**FINAL DRAINAGE REPORT FOR
HCD DRILLING
2601 EAST PLATTE AVENUE
COLORADO SPRINGS, COLORADO 80916**

July, 2021
Revised April, 2022

Job No. 1895.00
PCD Filing No.: MS-21-008

HCD DRILLING MINOR SUBDIVISION CONSTRUCTION DRAWINGS

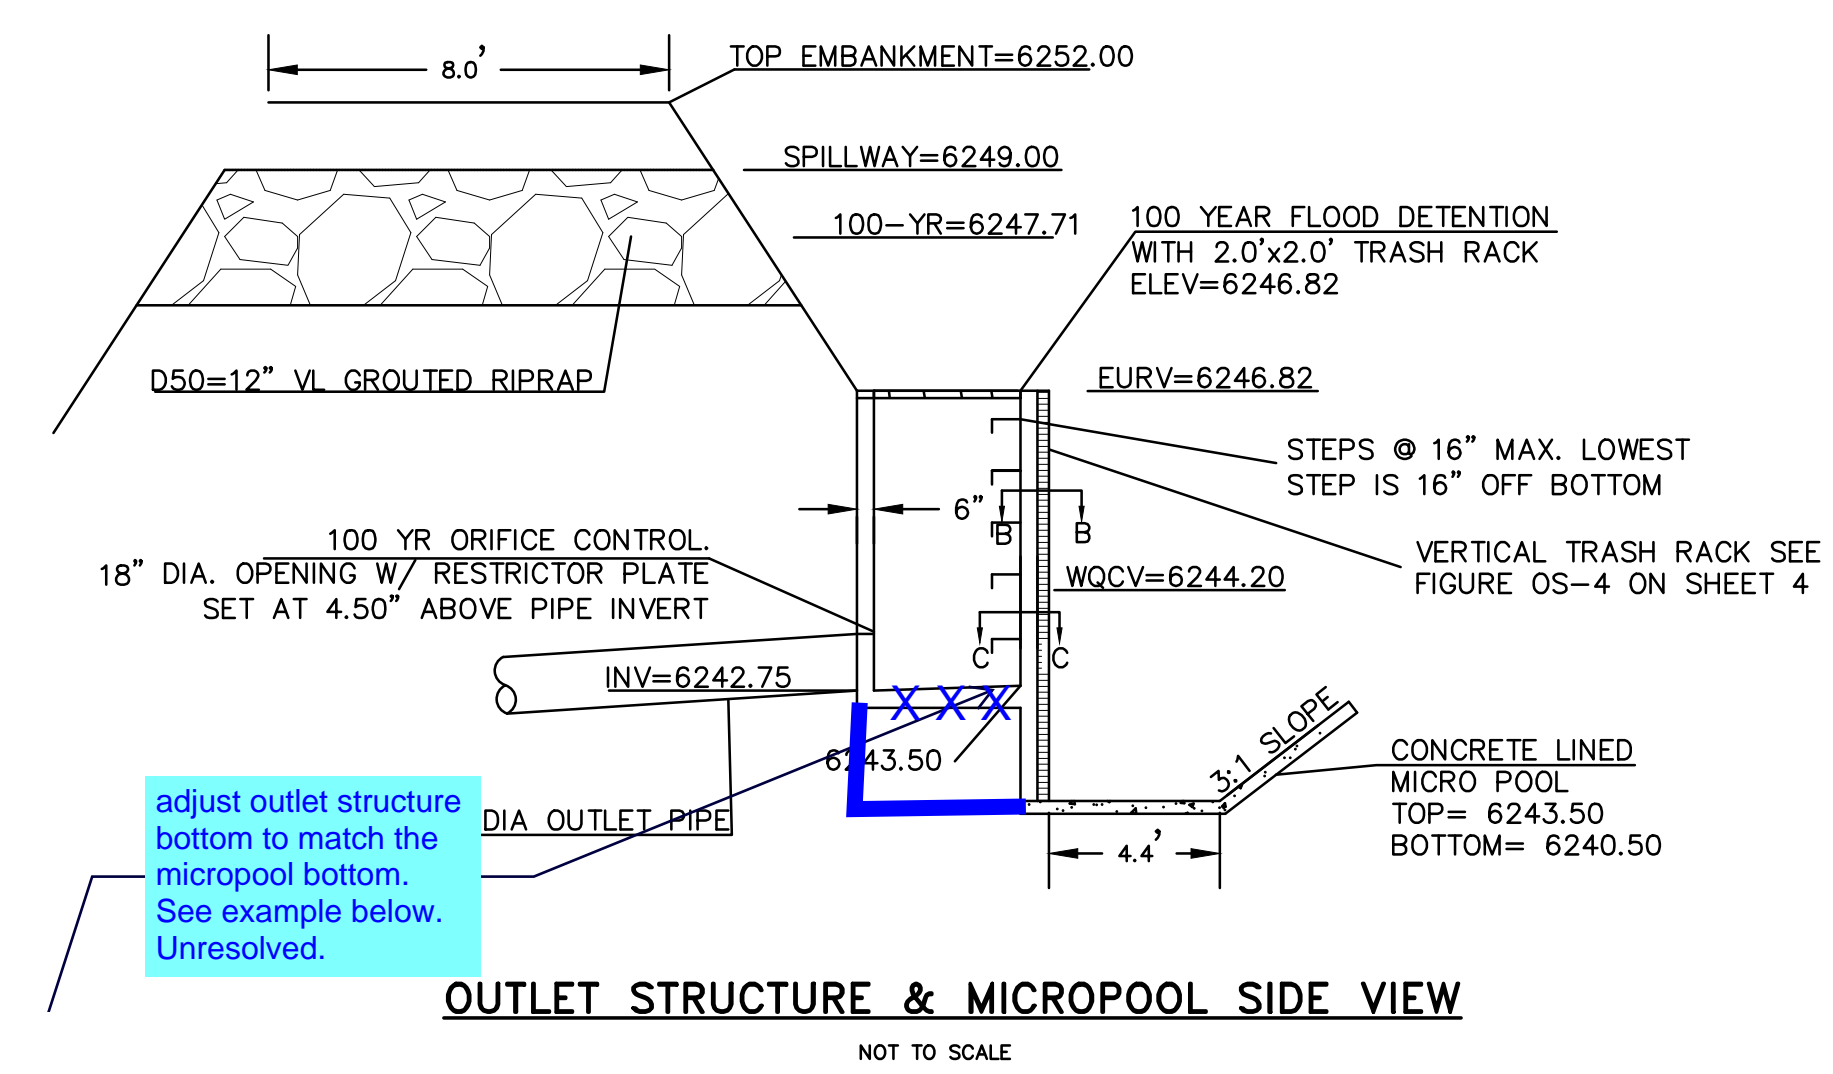
Remove Sheet.
Redline comments are cursory comments. Detailed comments will be provided to the construction drawings as part of the review of the site development plan application.
Unresolved.

Revise to identify the diameter of orifice.
